ADDENDUM NO. 2

Reference: New Tooele Applied Technology College
Utah College of Applied Technology – Tooele, Utah
DFCM Project No. 11064280

ADDENDUM NO. 2
February 10th, 2012

Tooele Applied Technology College New Building
Tooele, Utah

1 Roof Plan
1/16" = 1'-0"

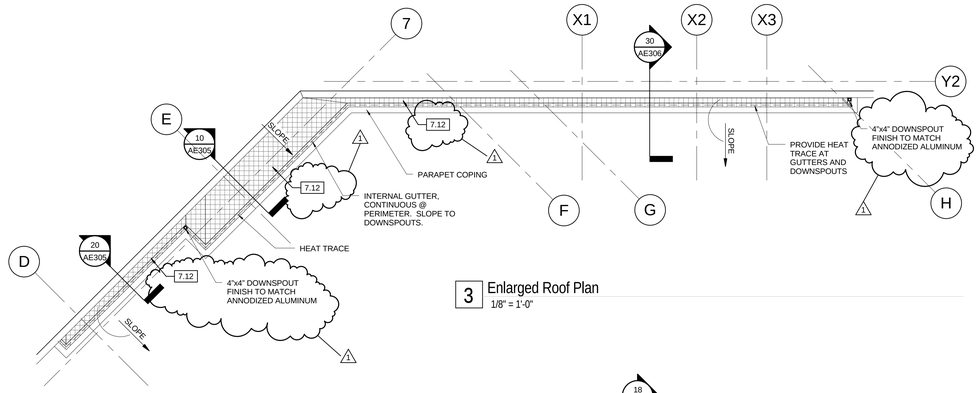
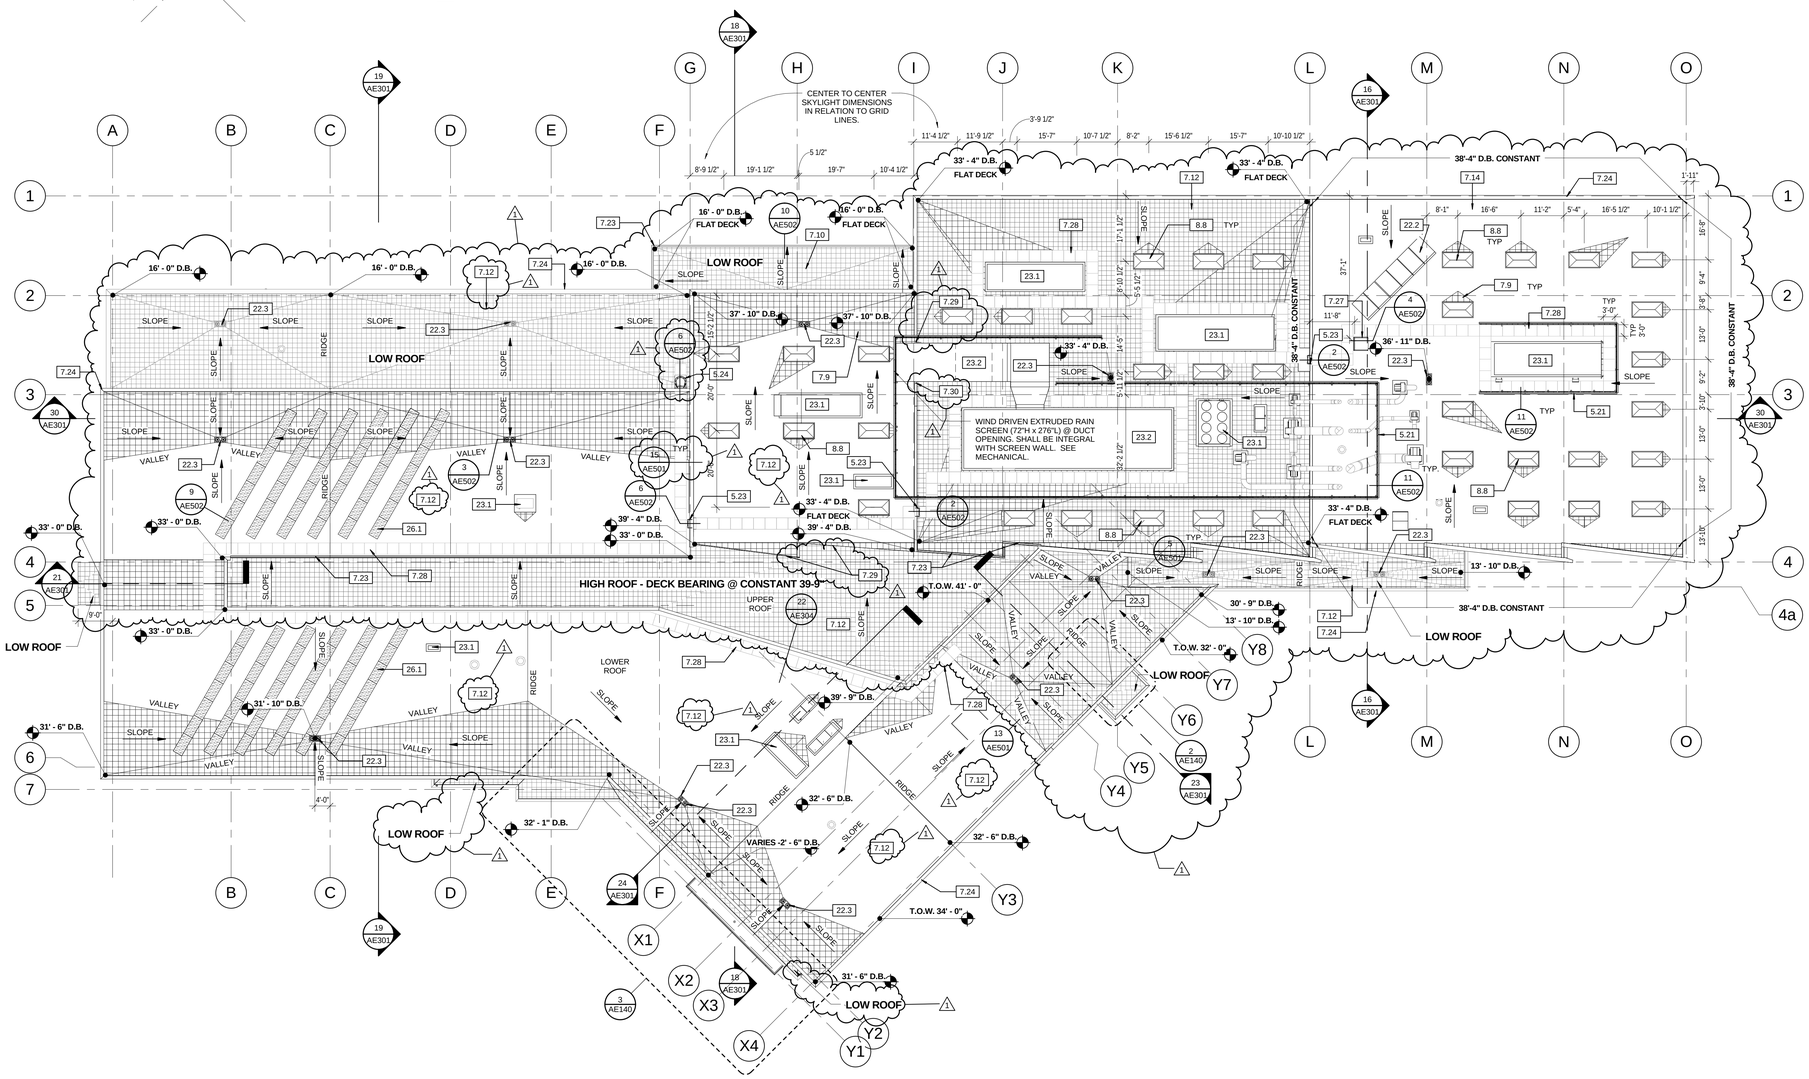
AD2-A11 Sheet AE140 Roof Plan 1, Roof Enlarged Plan 2, Enlarged Roof Plan 3
Clarified taper insulation and gutter locations, updated detail references and finishes, see attached sheet.

AE412

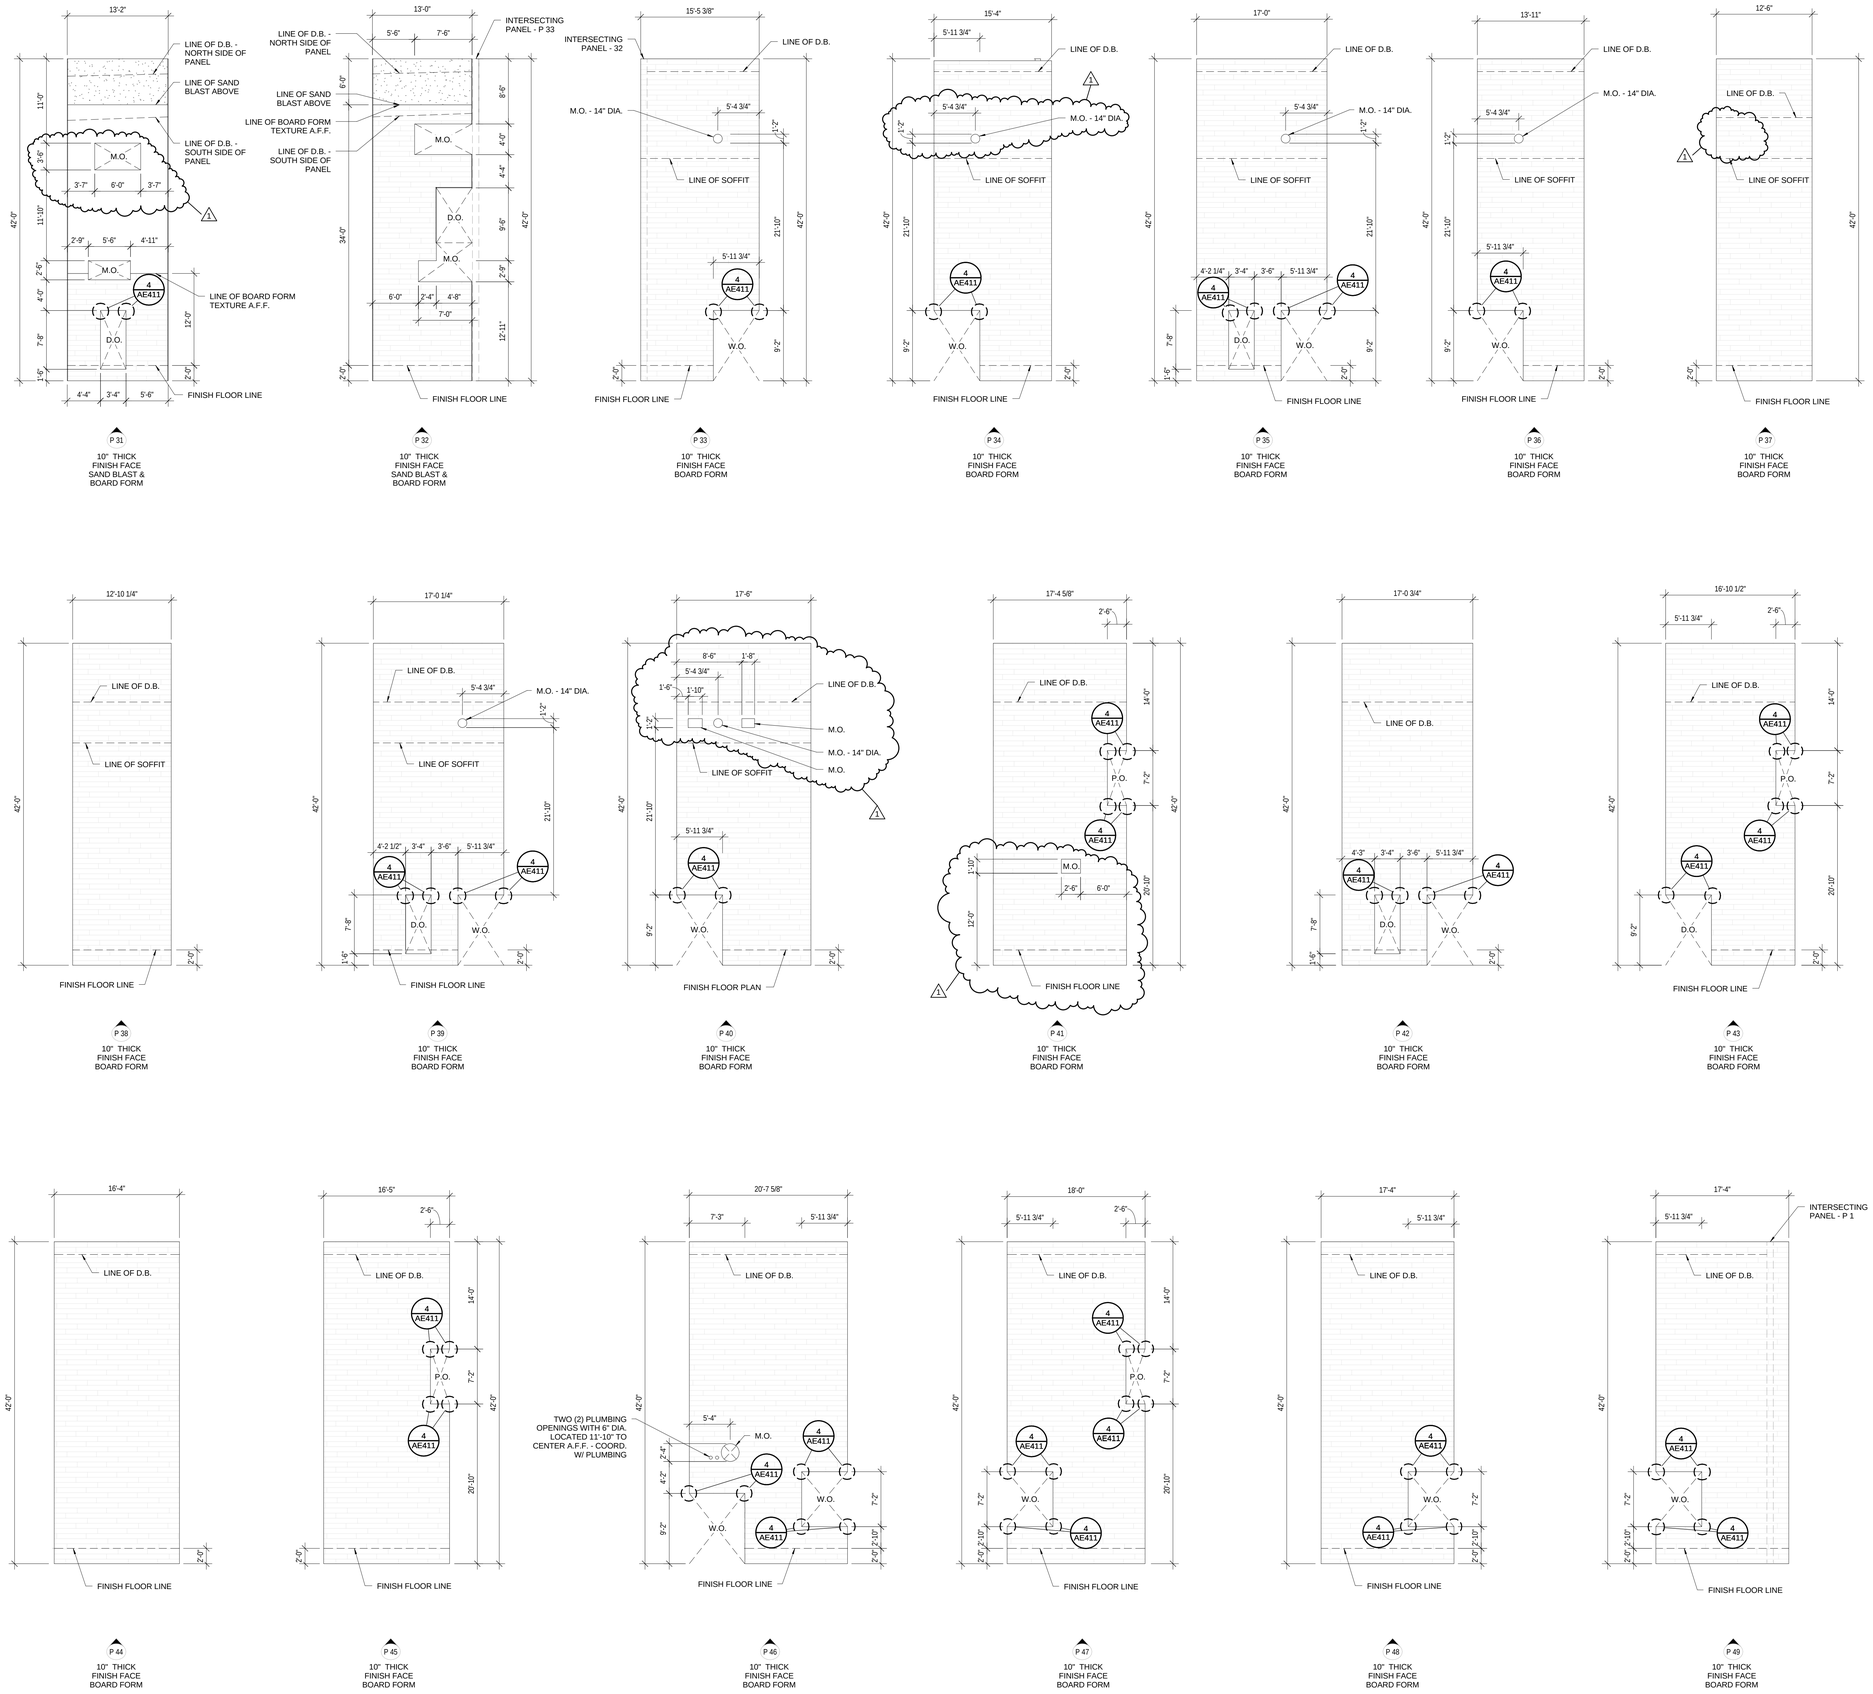
AD2-A22 Sheet AE412 Panels 21,22 and 30
Added or adjusted tilt panel penetrations. See attached sheet.

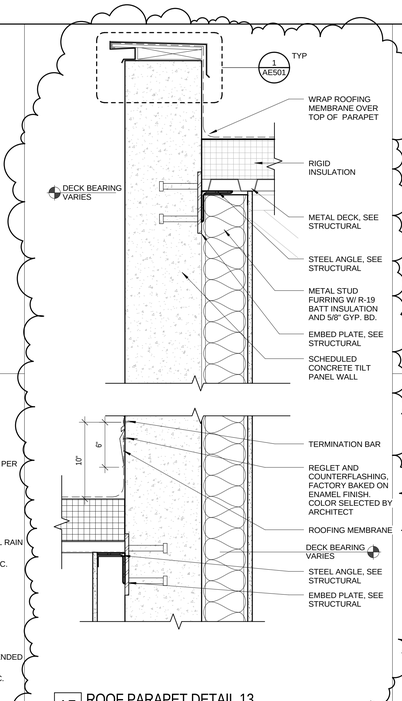
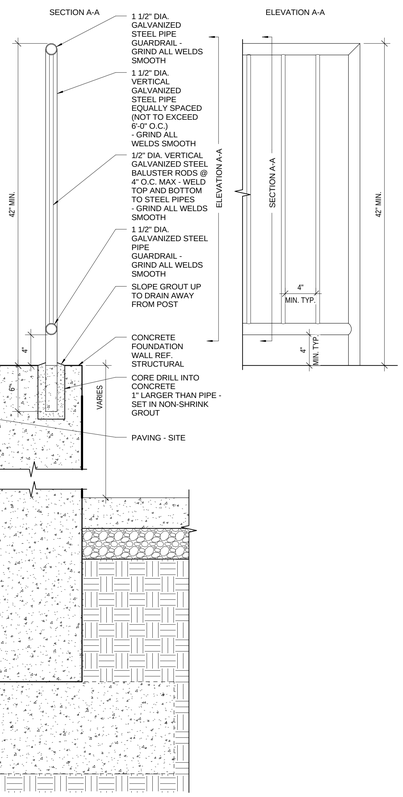
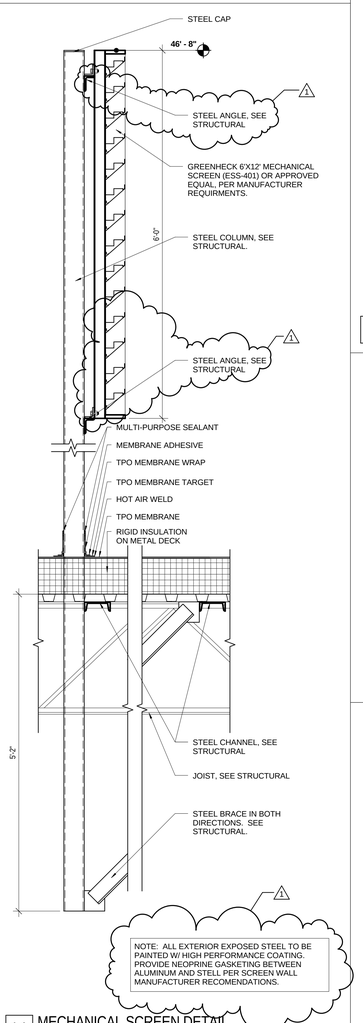
AD2-A26 Sheet AE502 Details, 2,6,7,10,11
Clarifications to detail components and notes. See attached sheet.

AE503

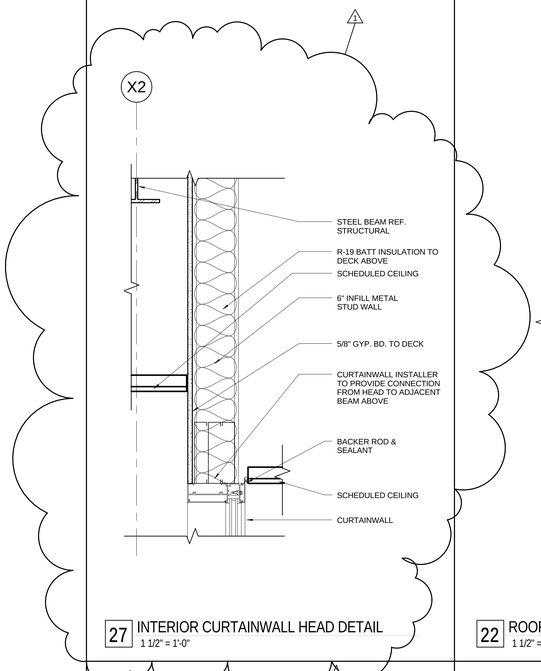
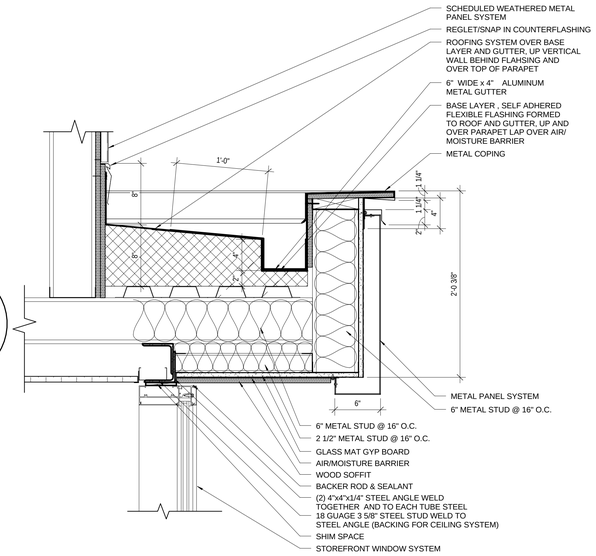
AD2-A27 Sheet AE503 Details, 1,11,16,21,22,23,27,28,29
Clarifications to detail components, dimensions and notes. See attached sheet.

AE601

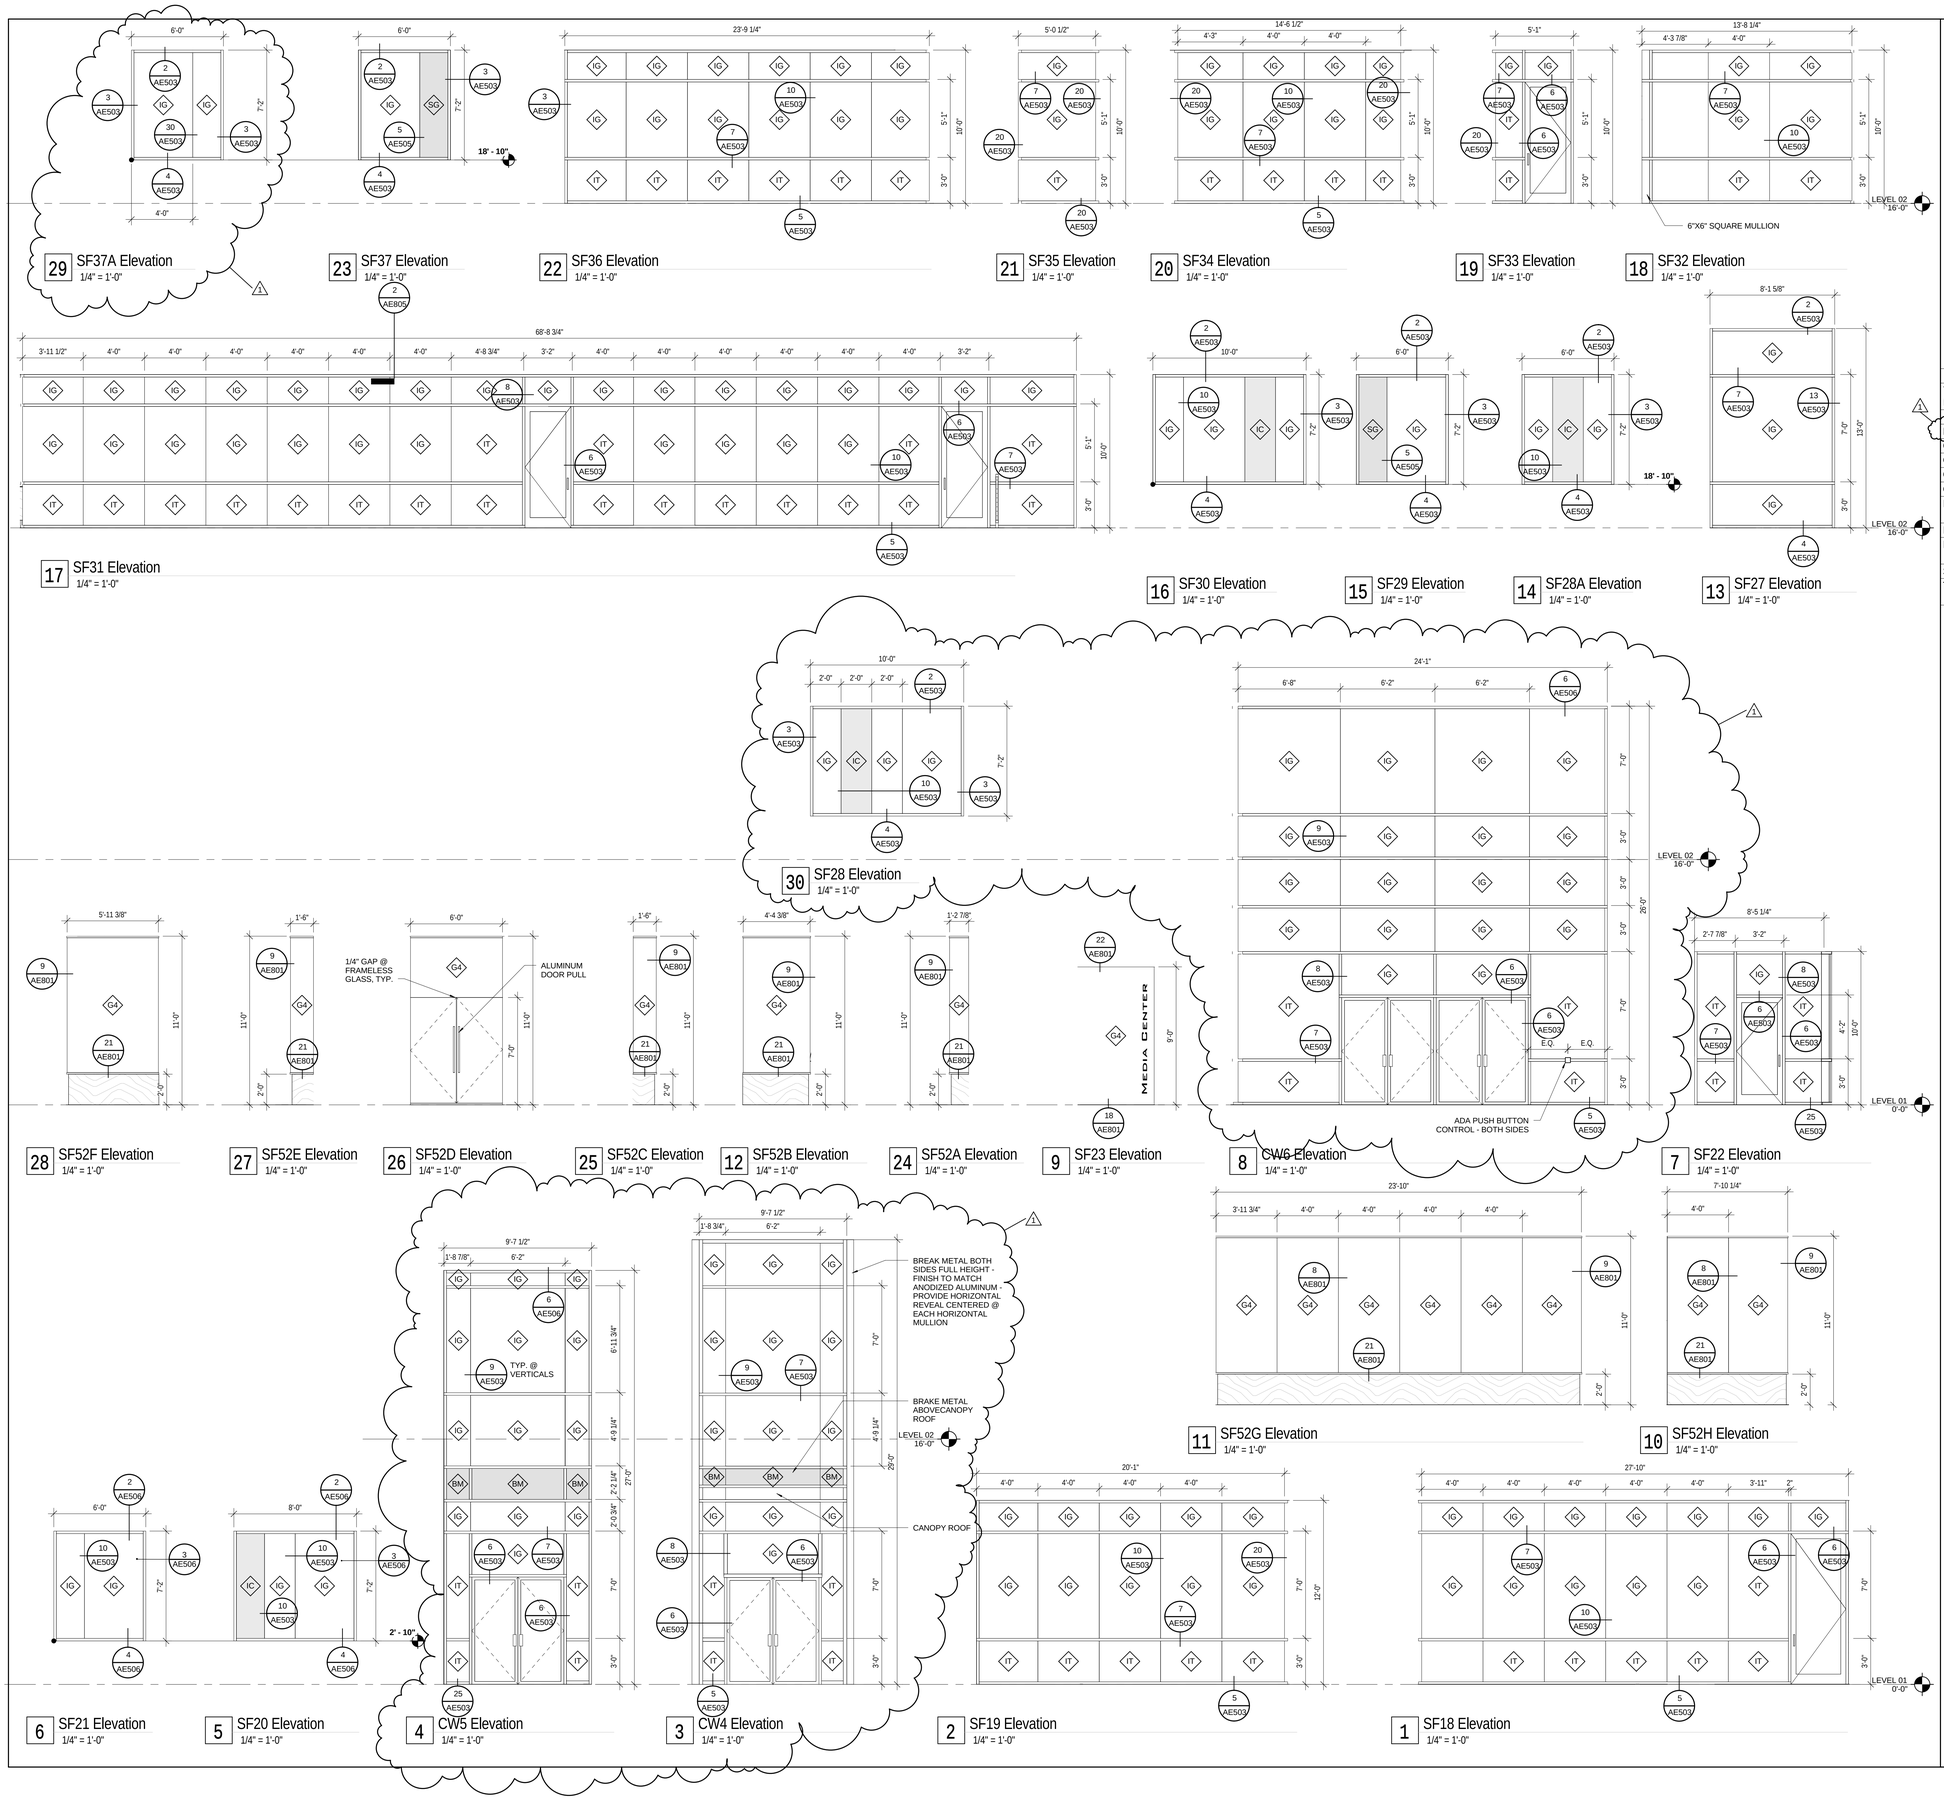
AD2-A30 Sheet AE601 Window schedule
Updates and clarifications to window schedule and blinds. See attached sheet.
